Proposal Name: Vanderburg Short Plat

File Number: 20-104493-LN

Decisions Included: Preliminary Short Plat (Process II)

Department Decision: Approval with Conditions

Figure 1 - Preliminary Short Plat Proposal

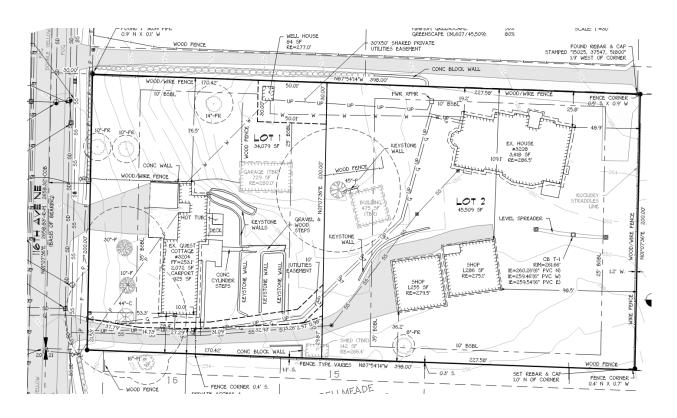
The original design was revised to remove three existing accessory structures to meet proposed building setbacks and to ensure a 10-foot setback from the proposed access easement.
